**ASSESSMENT REPORT
Invincible Colliery
Southern Extension Modification
(07_0127 MOD 5)**

Assessment Report
Section 75W of the
Environmental Planning and Assessment Act 1979

November 2017

Figure 10: Water Management System Catchment

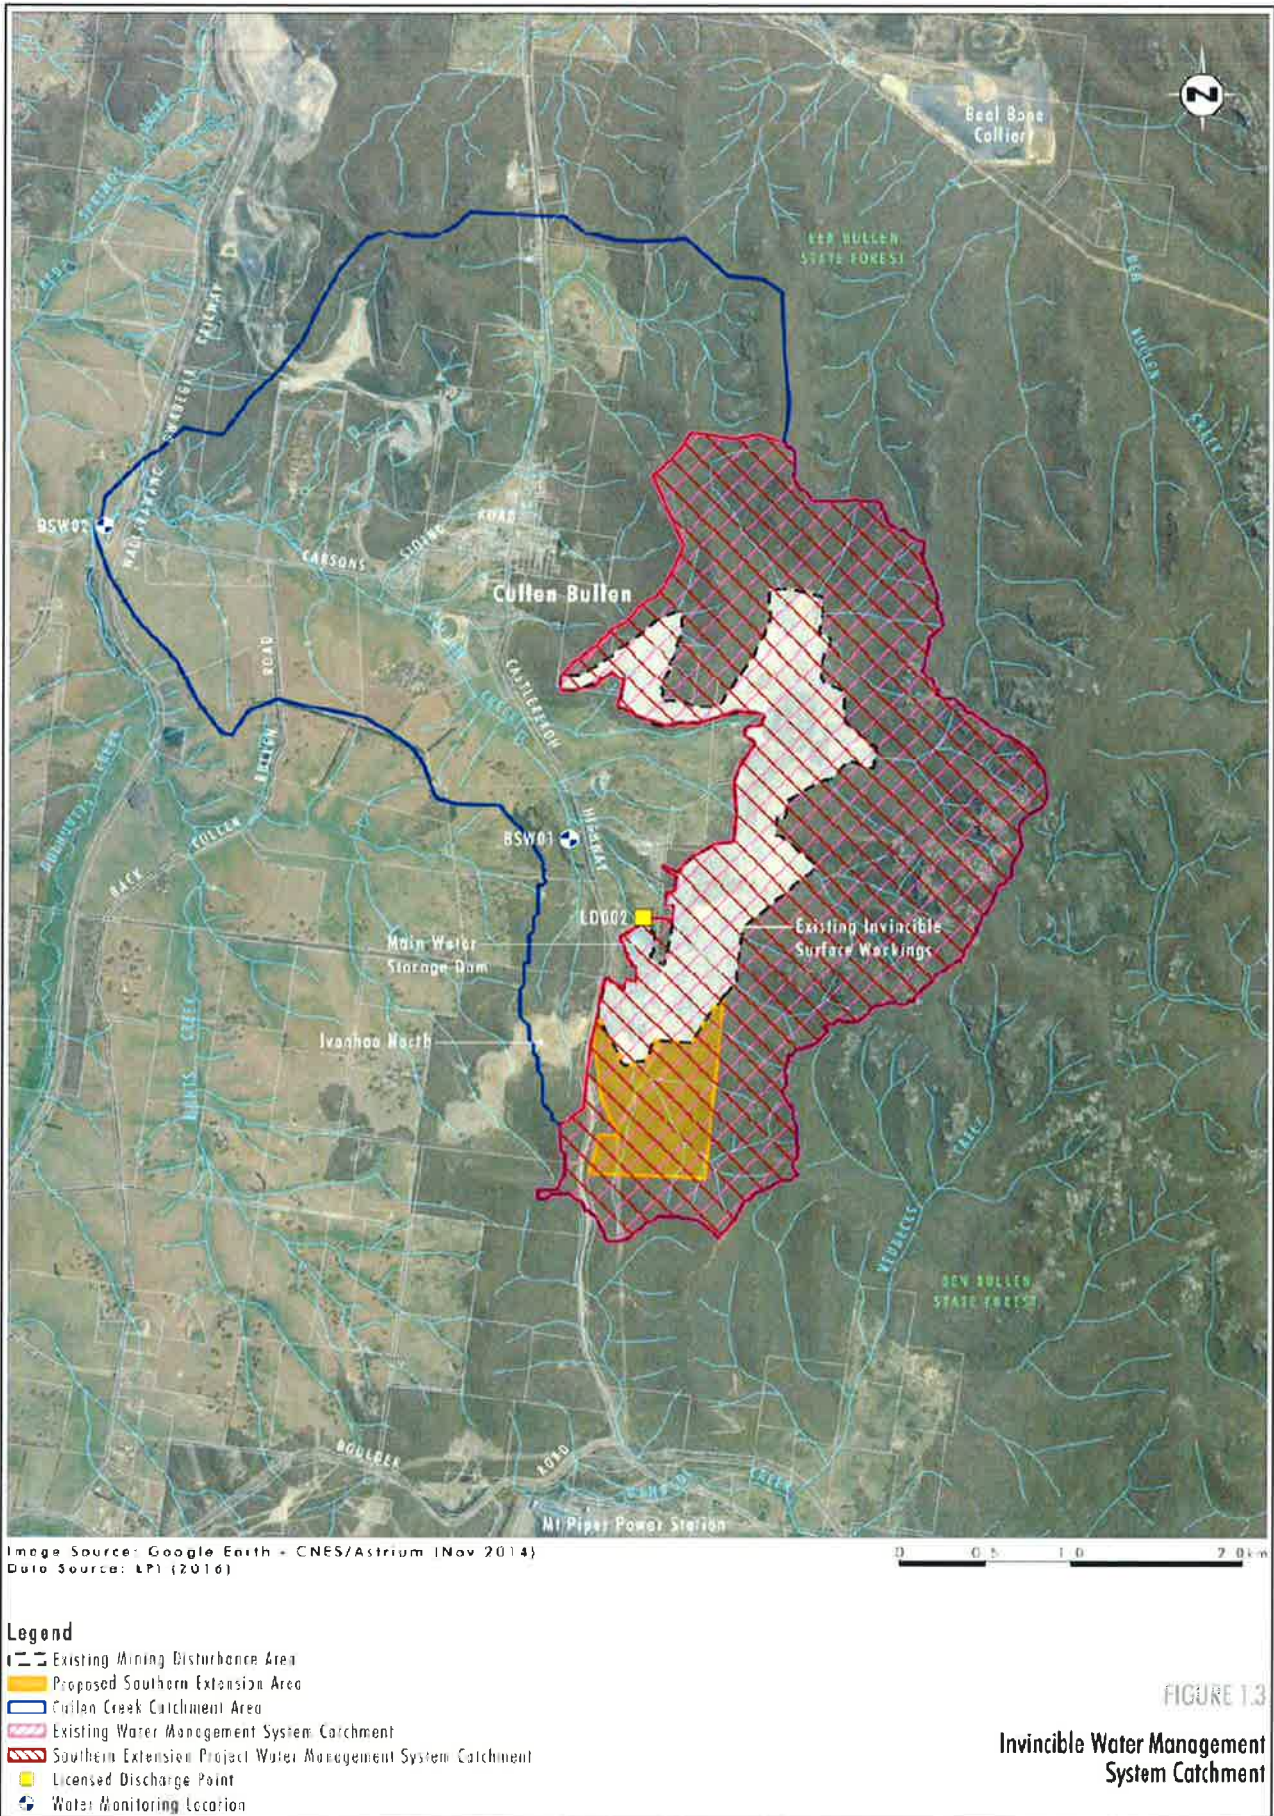
The existing operations and the Southern Extension Area are located within the Cullen Creek catchment. The proposed modification would not change the amount of surface water reporting to the dirty water management system as the Southern Extension area is located entirely within the catchment area of the existing water management system (see **Figure 10**).

The clean water diversions required by the existing water management plan at the Invincible Colliery do not operate in accordance with best practice. This results in some water from undisturbed areas reporting to the dirty water management system, rather than being diverted around the mine. Castlereagh Coal has not proposed to implement any additional diversion measures as part of the proposal due to topographical constraints associated with the construction of diversions and dams and the potential for additional biodiversity impacts.

Figure 11: Worst Case Noise Levels for Receivers 393 and 394

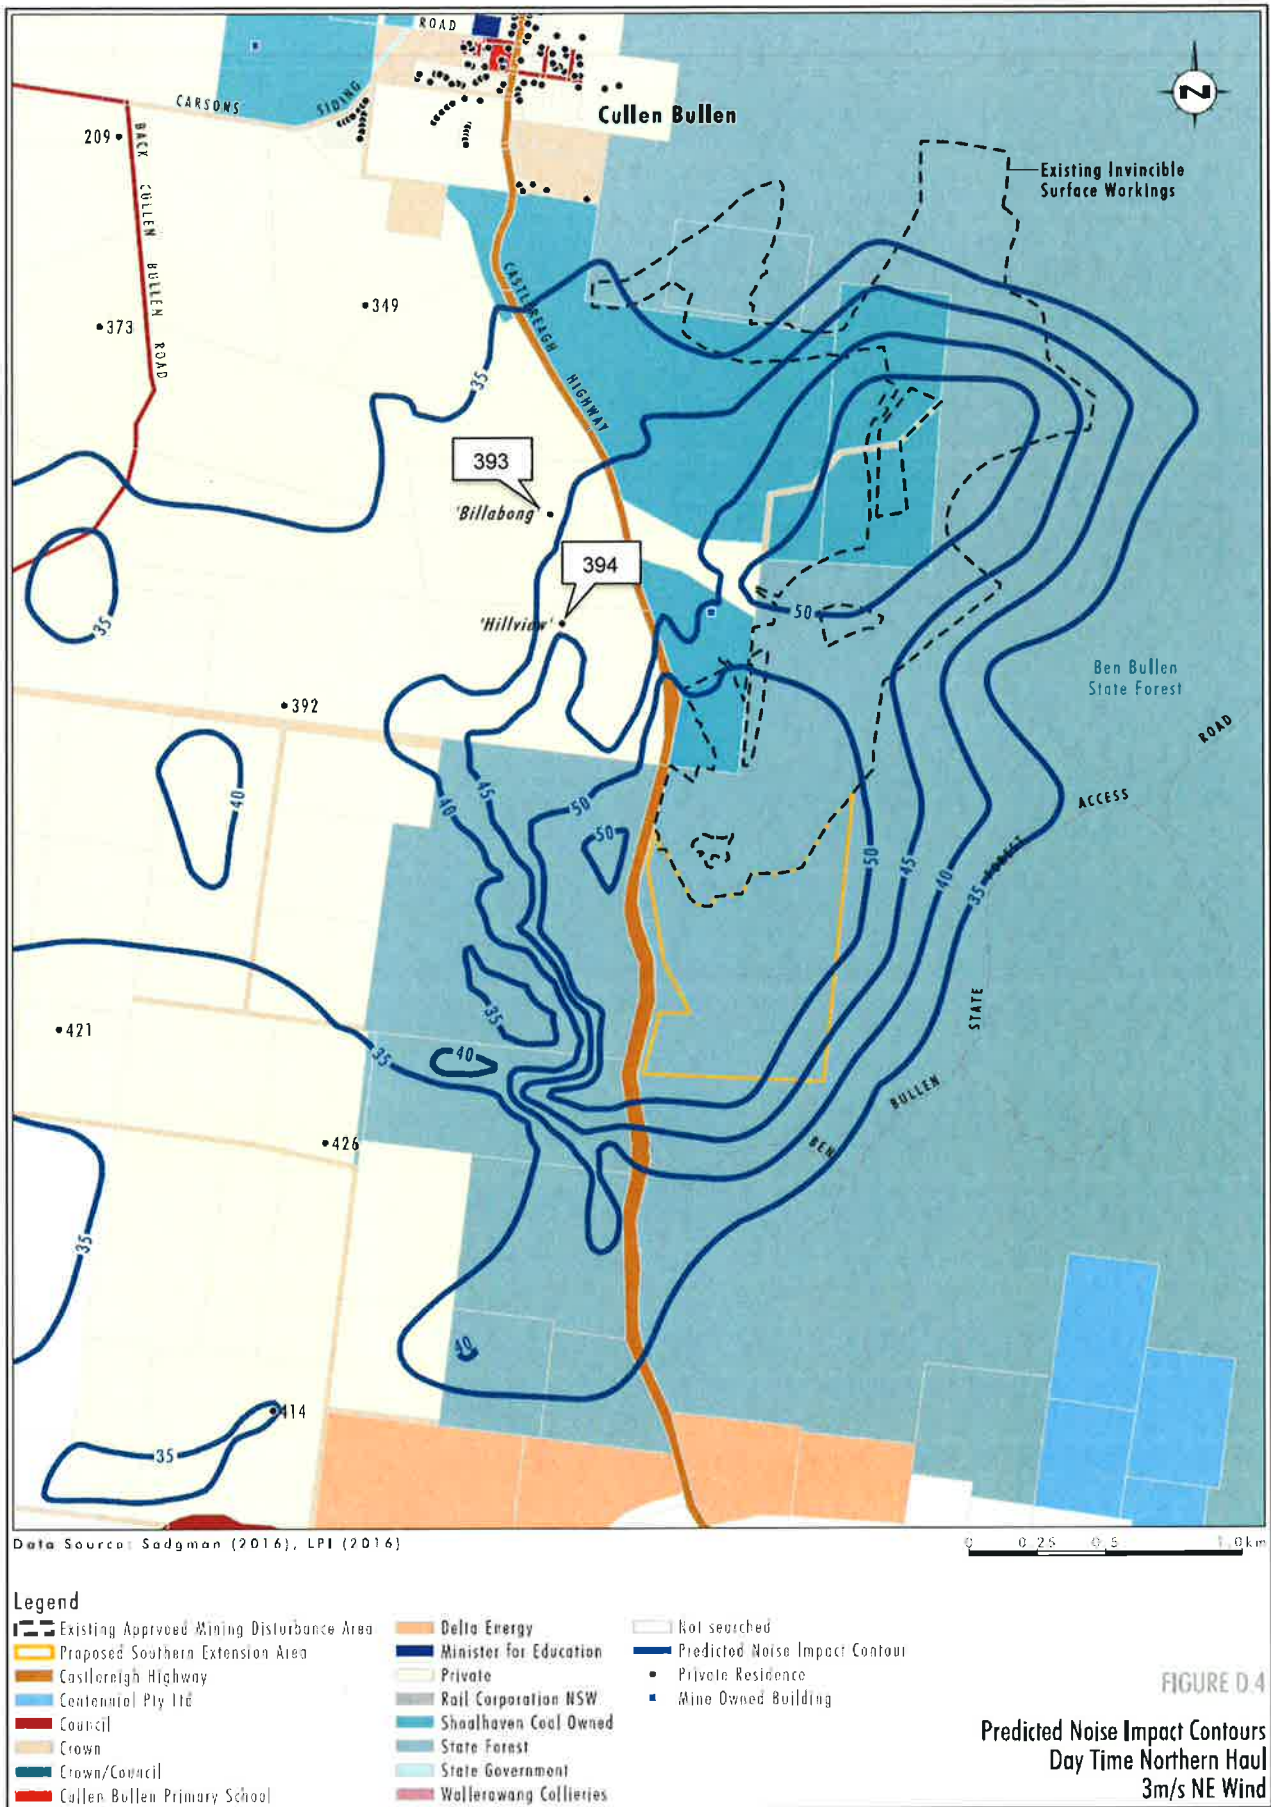
The worst-case noise levels are shown in **Table 5**. There would only be one exceedance of the Project Specific Noise Levels (PSNL) at one privately owned residence. Worst case noise levels at receivers 393 and 394 would coincide with the haulage of overburden to the eastern void. The noise contours associated with this scenario are shown in **Figure 11**.

Figure 12: Predicted Worst Case Air Quality Contours

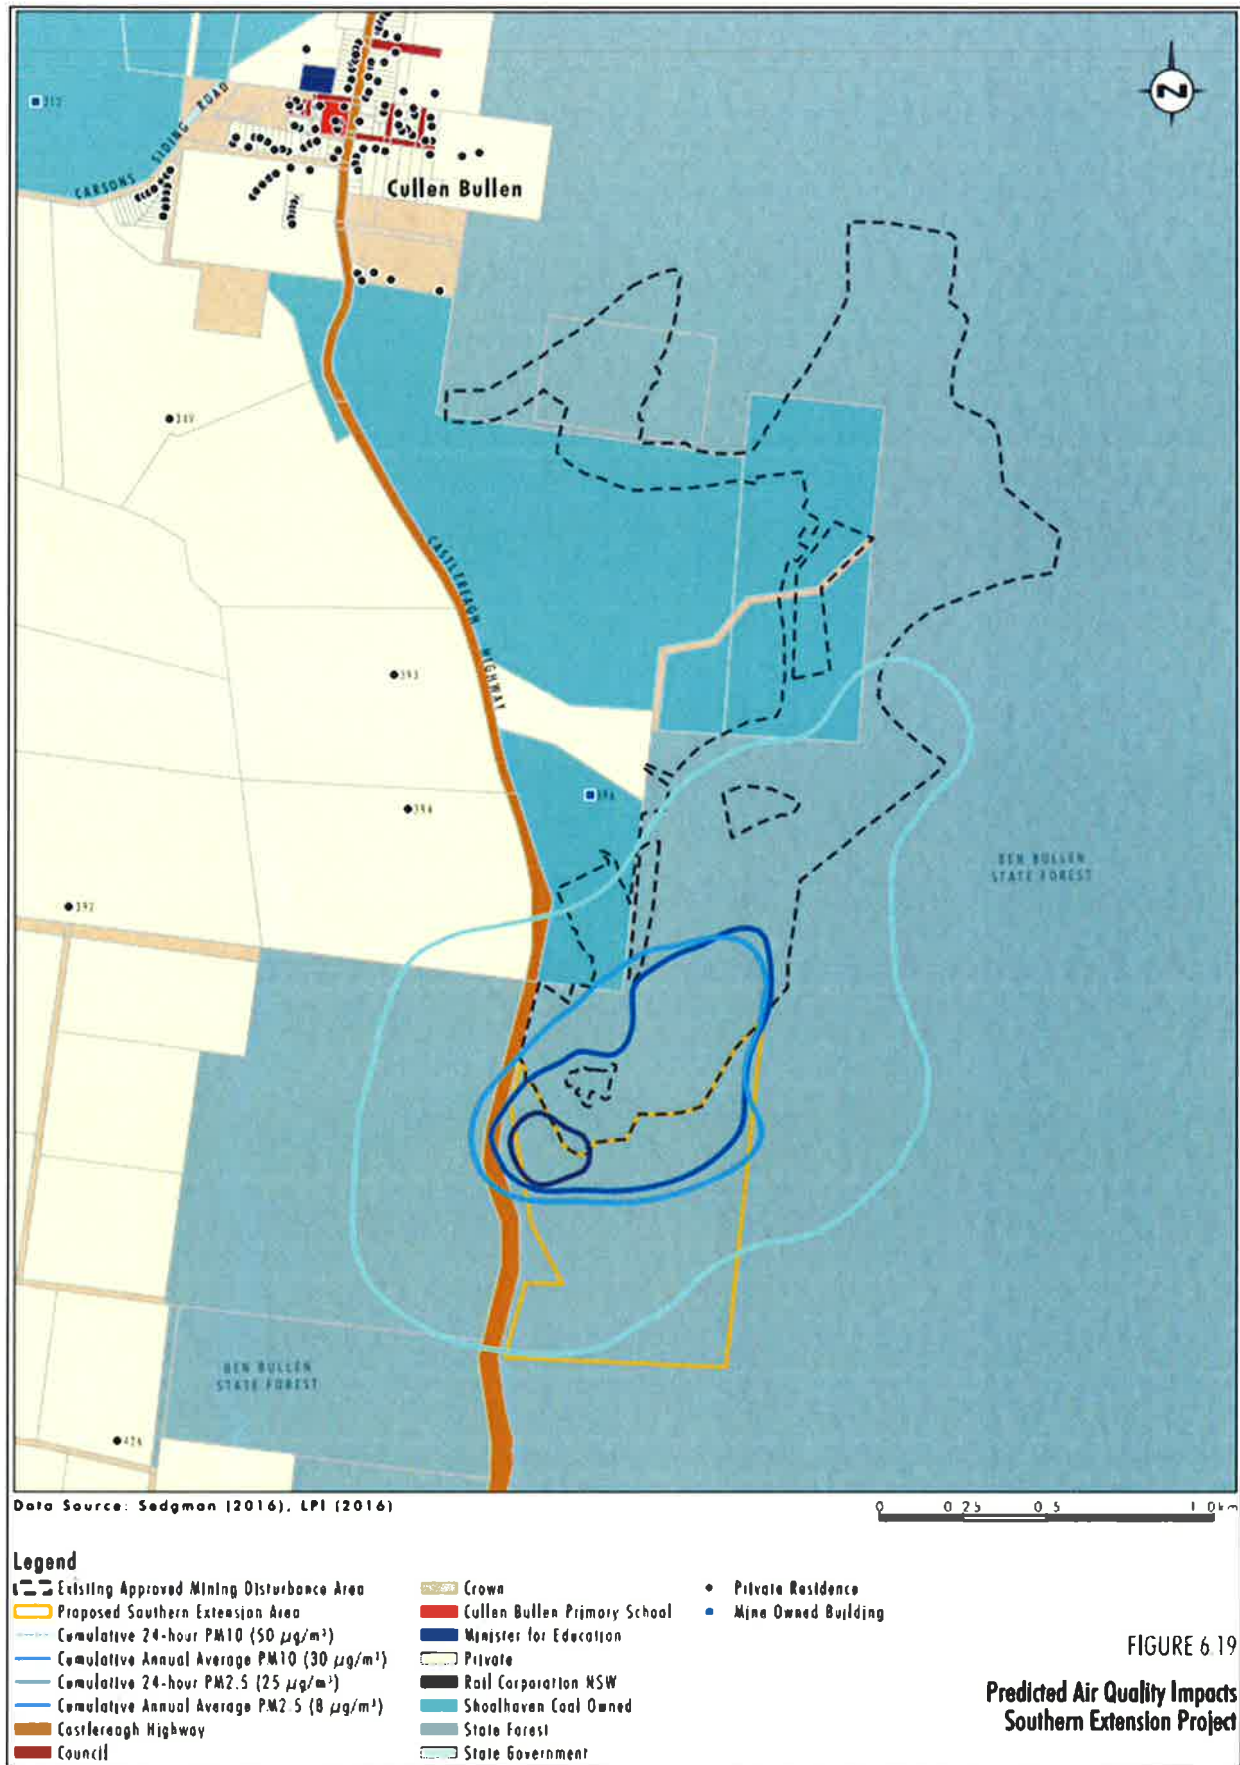
The EA includes an Air Quality Impact Assessment undertaken by Jacobs in accordance with the *Approved Methods for Modelling and Assessment of Air Pollutants in New South Wales* (EPA 2005). It modelled the predicted contributions from the proposal together with background levels for total suspended particulates (TSP), fine particle matter (PM_{2.5} and PM₁₀) and deposited dust. The predicted worst-case dust contours are shown in **Figure 12**.

EPA raised no concerns with the assessment of air quality impacts. Nevertheless, the Department has recommended a range of conditions to reflect contemporary standards for mining projects in NSW. This includes a requirement to prepare and implement a revised Air Quality Management Plan for the project.
